**APPLICATION FOR PERMISSION UNDER SECTION 16 TOWN PLANNING APPLICATION  
FOR PROPOSED MINOR RELAXATION OF PLOT RATIO RESTRICTION FOR PERMITTED  
FLAT WITH SHOP AND SERVICES AND SOCIAL WELFARE FACILITY (RESIDENTIAL  
CARE HOME(S) FOR THE ELDERLY) IN "RESIDENTIAL (GROUP A)" ZONE IN LOT  
NO. 3678 in D.D. 120, YUEN LONG, NEW TERRITORIES**

**Town Planning Application No. A/YL/319 – Submission of Further Information (5)**

**Proposed Minor Relaxation of Plot Ratio Restriction for Permitted Flat with Shop and Services and Social Welfare Facility (Residential Care Home for the Elderly) Uses in “Residential (Group A)” Zone at Lot 3678 in D.D. 120, Yuen Long, New Territories (Application No. A/YL/319)**

Departmental Comments (Email from Planning Department dated 5.7.2024, 28.8.2024 and 29.8.2024)

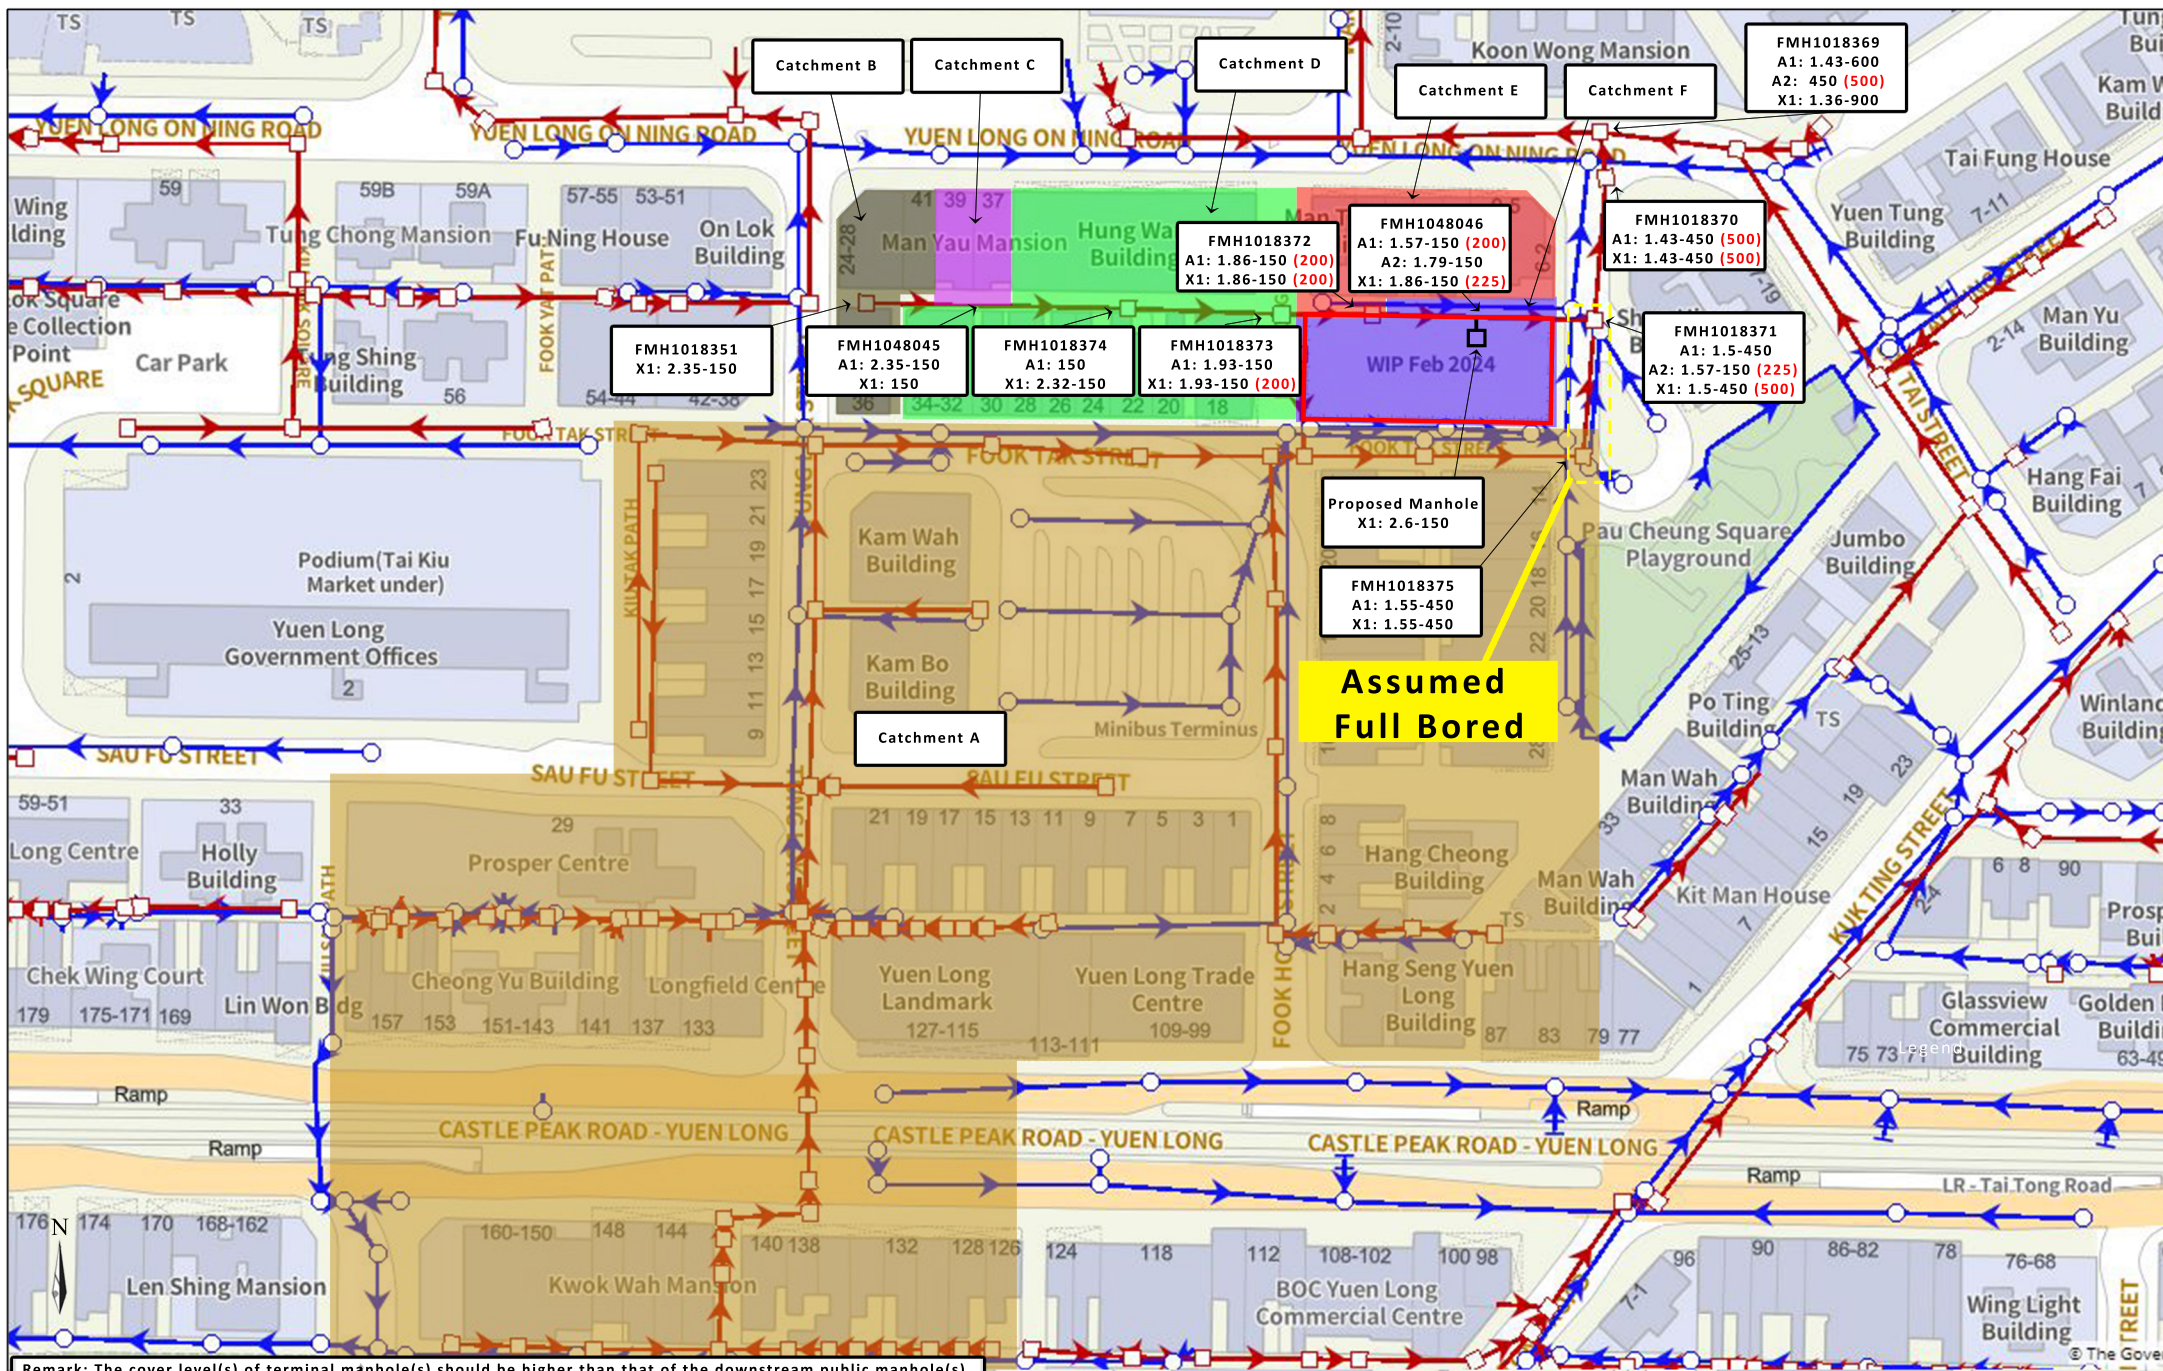
<p><b><u>1. Drainage Services Department</u></b> <b><u>(28.8.2024)</u></b></p>	
<p>a) Appendix 3: Please indicate the proposed terminal manhole and its connection with details on drawing.</p>	<p>Please be clarified on the proposed terminal manhole and its connection with details in Appendix 3 of the revised Sewerage Impact Assessment (SIA) report (<b>Attachment 2</b>).</p>
<p>b) Appendix 3: According to the drawing, for FMH1018371, the incoming pipe size (A2) is not consistent. The outlet pipe (X1) should be 500mm dia. pipe instead of 225mm dia. pipe.</p>	<p>Please be clarified on the connection details for FMH1048046 and FMH1018371 in Appendix 3 of the revised SIA report (<b>Attachment 2</b>).</p>
<p>c) Appendix 3: Please revise the appendix cover and figure title as "Existing and Proposed Sewerage Plan".</p>	<p>For clarification, the appendix cover and figure title are renamed to "Existing and Proposed Sewerage Plan" in Appendix 3 of the revised SIA report (<b>Attachment 2</b>).</p>

<p>d) Response to comment (h): Please add the following in the report text and drawing note that "The cover level(s) of terminal manhole(s) should be higher than that of the downstream public manhole(s)."</p>	<p>For clarification, "The cover level(s) of terminal manhole(s) should be higher than that of the downstream public manhole(s)." is incorporated into Section 3.4 and Appendix 3 of the revised SIA report (<b>Attachment 2</b>).</p>
<p><b><u>2. Environmental Protection</u></b> <b><u>Department (29.8.2024)</u></b></p>	
<p><b>Comments on the SIA Report</b></p>	
<p>a) Appendix 3 -</p> <p>i. The proposed pipe sizes in FMH1018373, FMH1048046, FMH1018371 and invert levels in FMH1018371 are still inconsistent with the proposed upgraded pipe works and drainage record plan, please check and revise.</p>	<p>Please be clarified on the proposed pipe sizes in FMH1018373, FMH1048046, FMH1018371 and invert levels in FMH1018371 in the Appendix 3 of the revised SIA report (<b>Attachment 2</b>).</p>

<p>ii. Please show the information of the proposed manhole for the proposed connection sewer to FMH1048046 in the drawing.</p>	<p>For clarification, the information of the proposed manhole for the proposed connection sewer to FMH1048046 is shown in Appendix 3 of the revised SIA report (<b>Attachment 2</b>).</p>
<p>b) Appendix 6 - Catchment Inflow Factor for "Yuen Long" instead of "Central Kolwoon" should be quoted in Remark [1], please revise.</p>	<p>Please be clarified on the Catchment Inflow Factor to be "Yuen Long" in Remark [1] in Appendix 6 of the revised SIA report (<b>Attachment 2</b>).</p>
<p>c) 3. Appendix 7 - Please check the sewage flow of FMH1018374-FMH1018373 and clarify if sewage flow from catchment D is included or not.</p>	<p>Please be clarified that Catchment D is included in the "Catchment" column for FMH1018374 to FMH1018373 in Appendix 7 of the revised SIA report (<b>Attachment 2</b>).</p>

Remark: The cover level(s) of terminal manhole(s) should be higher than that of the downstream public manhole(s).
